DATE: February 14, 2024

<u>Certificate of Appropriateness Request:</u>	H-14-22
<u>Applicant:</u>	Jim Potter/Old Towne Development
<u>Location of Subject Property:</u>	74, 76, 78 Cabarrus Ave W
<u>PIN:</u>	5620-87-0418
<u>Staff Report Prepared by:</u>	Autumn James, AICP - Planning & Development Manager

- On April 13, 2022, Jim Potter with Old Towne Development applied for a Certificate of Appropriateness under Concord Development Ordinance (CDO) §9.8 to construct three (3), two-story units with detached two (2) car garages.

Previously Submitted for 1/19/16 Planning & Zoning Commission

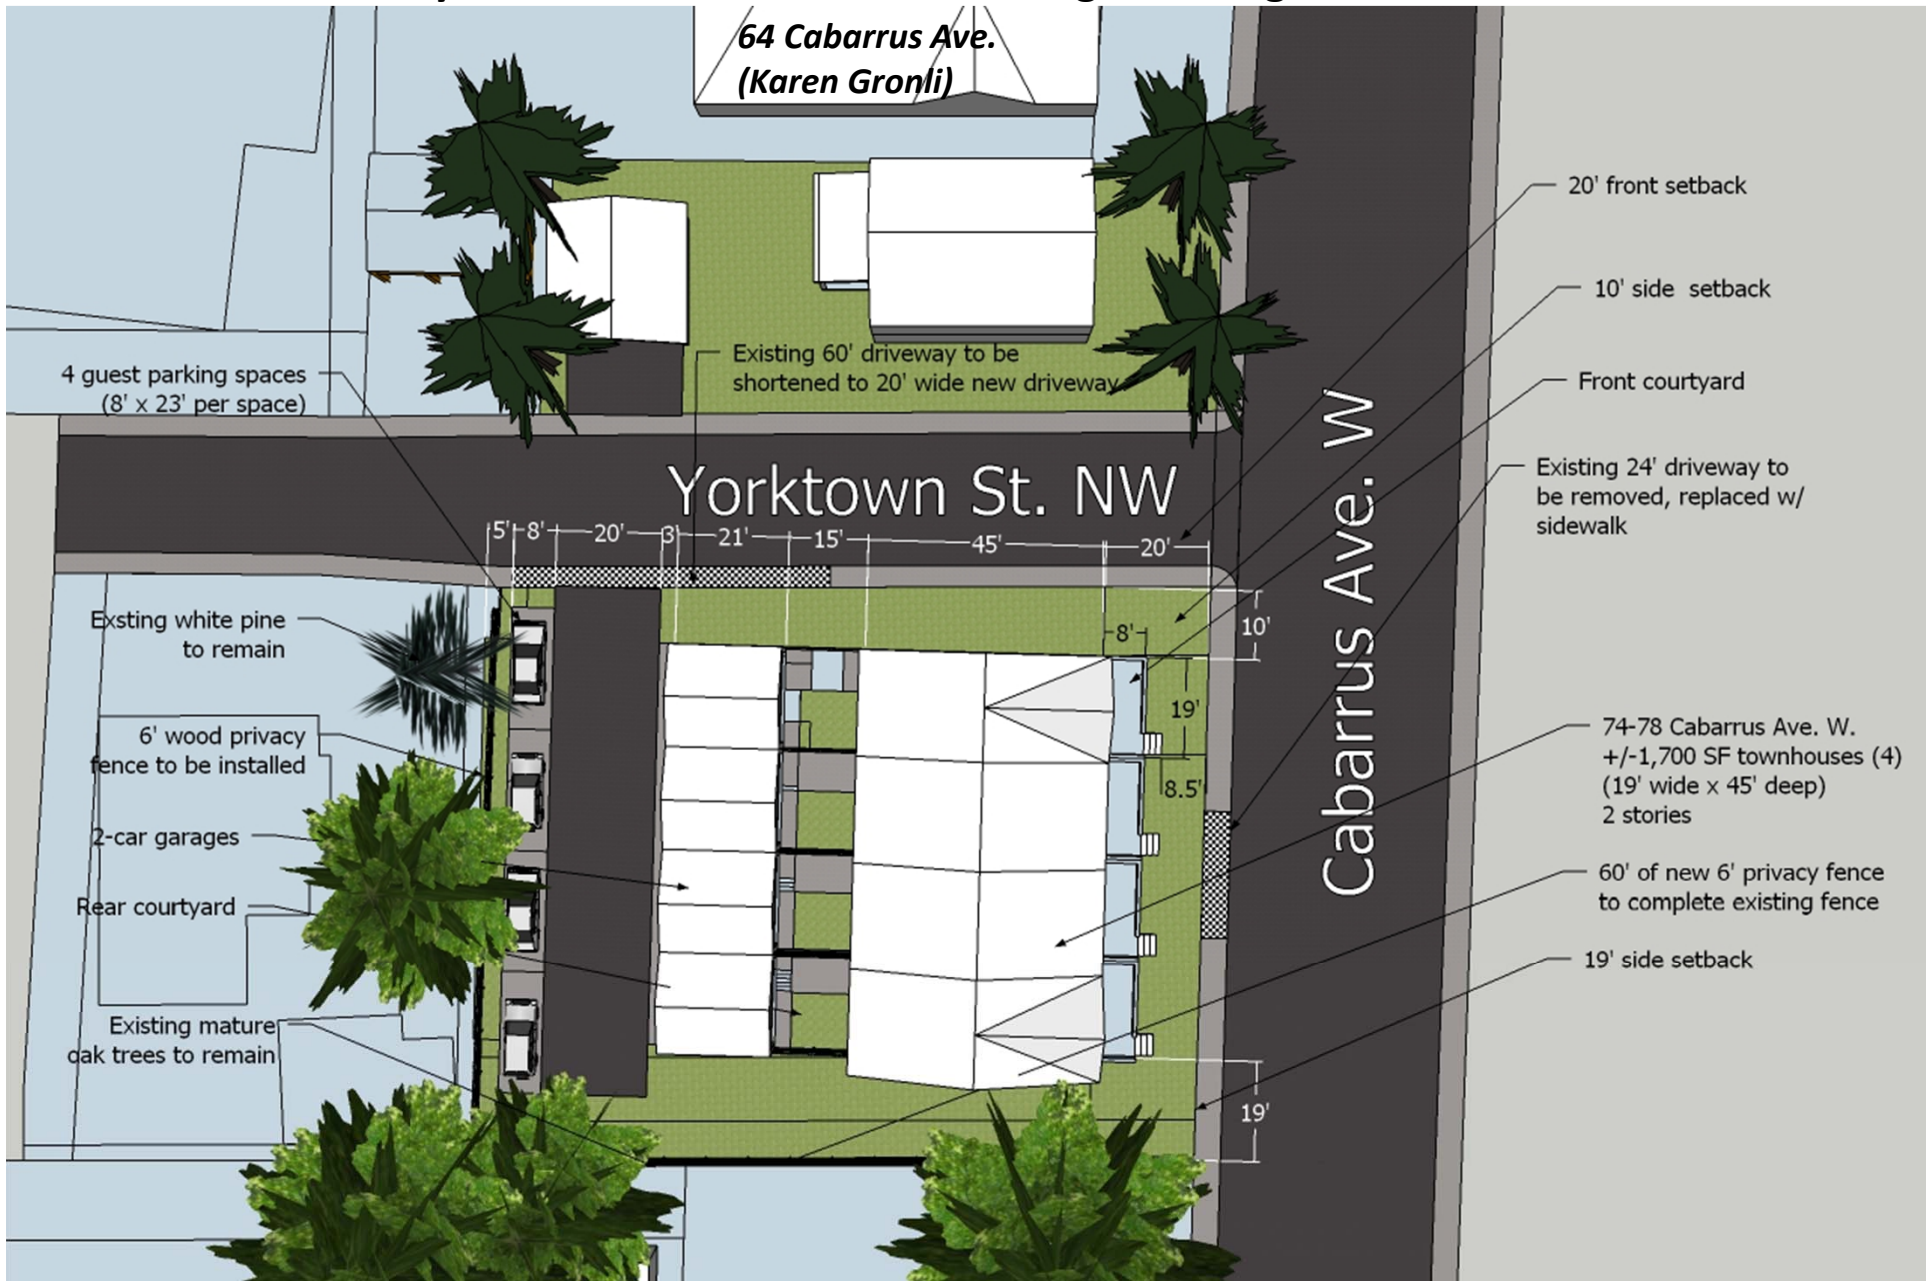
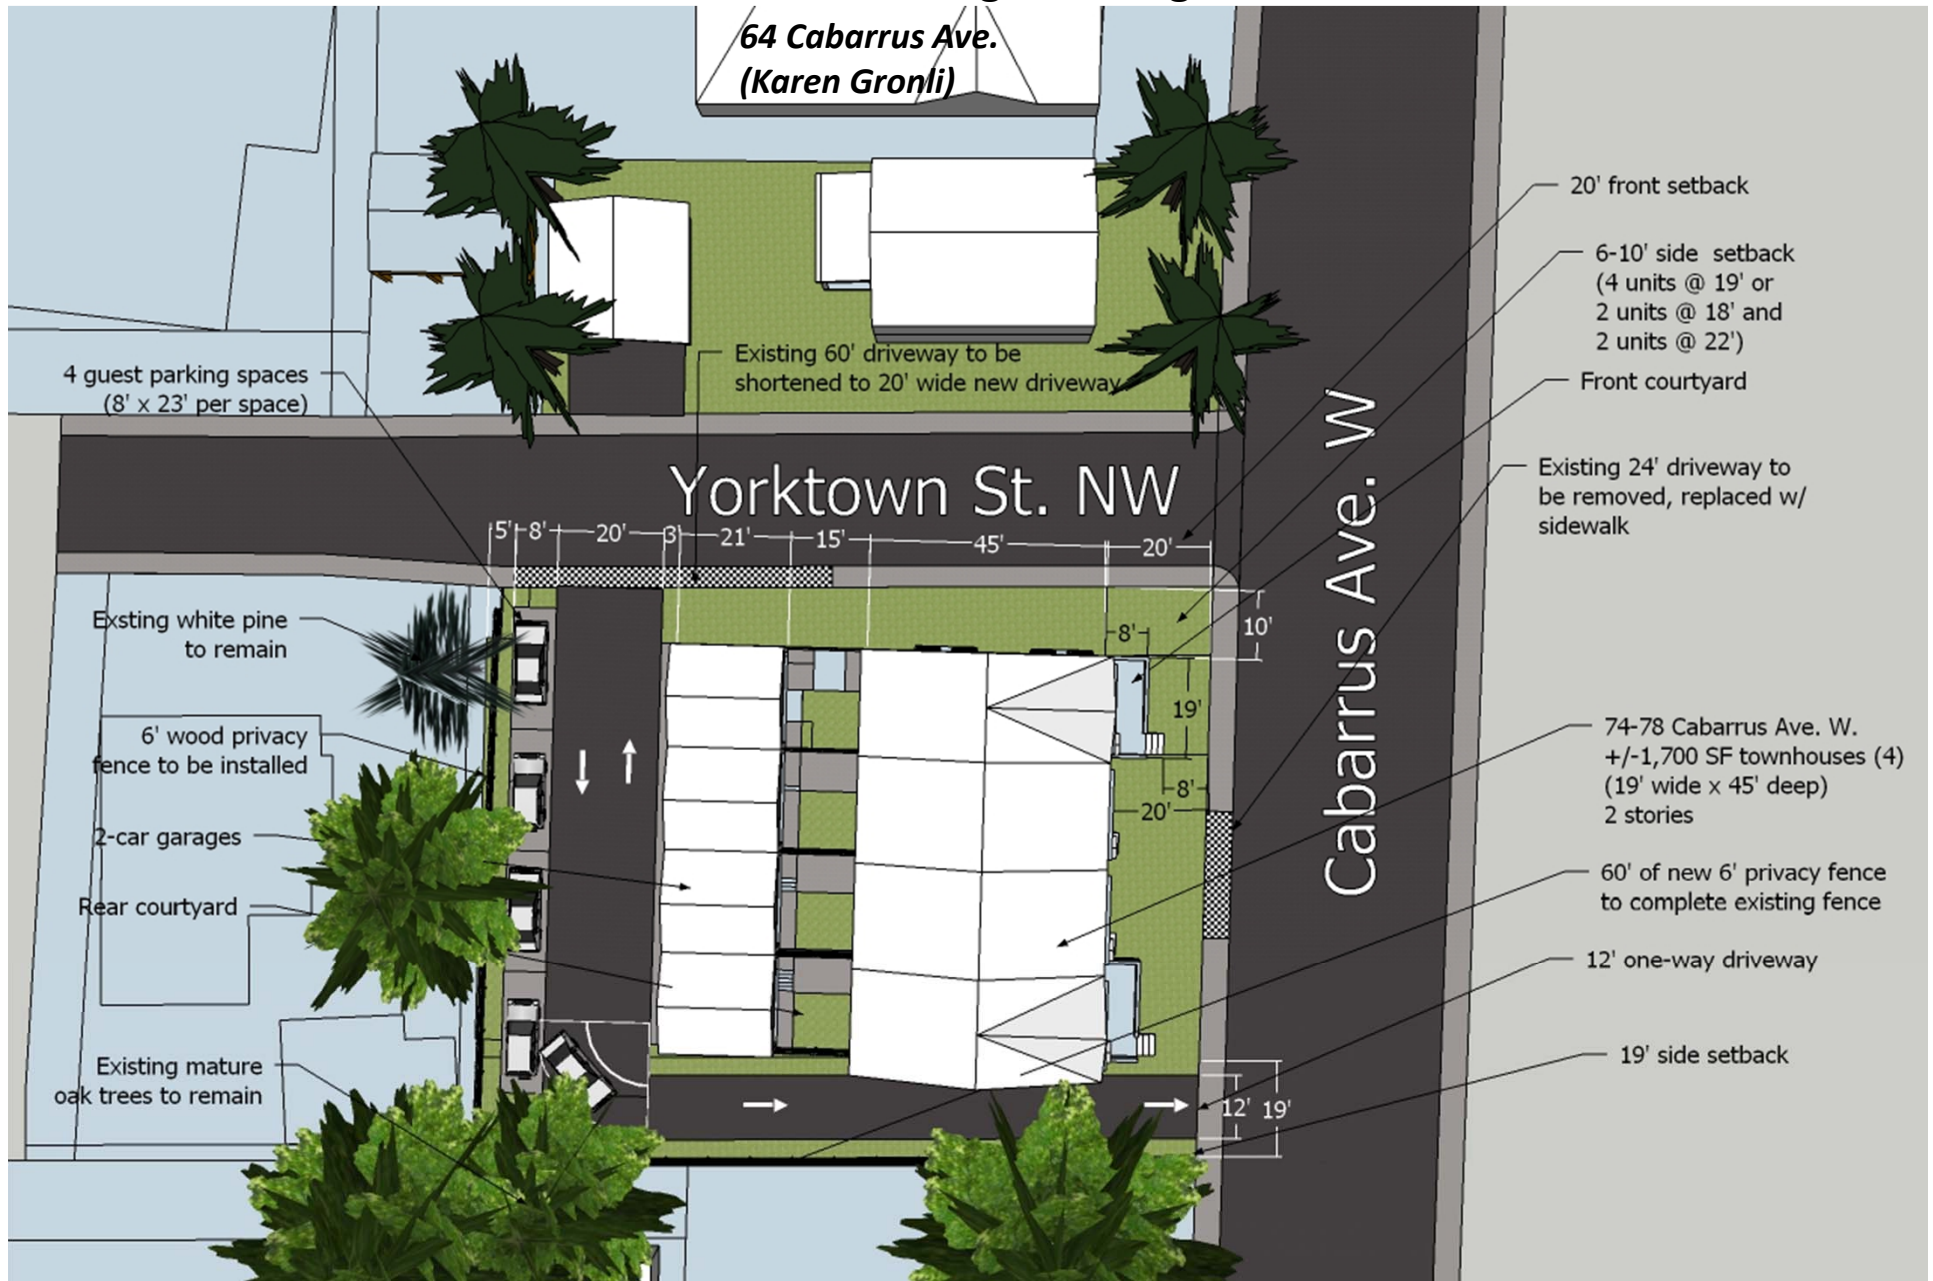
- Mr. and Mrs. Killough noted that misunderstanding about the project has been spread via neighborhood-based petitions.
- Planning staff clarified that the existing renderings are massing models and do not represent any architectural elements (i.e. brick, siding, roof lines, etc.). Architectural elements will be reviewed and approved by the Historic Preservation Commission (HPC).
- Mr. and Mrs. Killough noted that the most realistic redevelopment scenario for 74-78 Cabarrus Ave. W. is townhomes, given the demographics (Millennials, Baby Boomers) and general interest in low-maintenance housing options (i.e. little/no yard to maintain, minimal exterior house maintenance required).

- Mr. Ward took issue with the proposed townhomes having back-of-sidewalk setbacks ranging from 20 feet to 8 feet, citing that most surrounding setbacks are 30 feet. **Staff noted that the proposed setbacks are site-specific in response to concerns from Bill and Rebecca Patten (90 Cabarrus Ave.). Staff showed a development scenario assuming Residential Compact (RC) zoning, which would require 20 foot setbacks on both frontages of Yorktown St. NW and Cabarrus Ave. NW, pushing the building footprint south and west, precluding the ability to have a secondary driveway access onto Cabarrus Ave. W. (requested by neighbors) and removing 4 guest parking spaces along the rear driveway.**

All models are for height/massing purposes only, not detailed architecture. Historic Preservation Commission will review detailed architecture (i.e. materials, roof pitch/style, etc.)
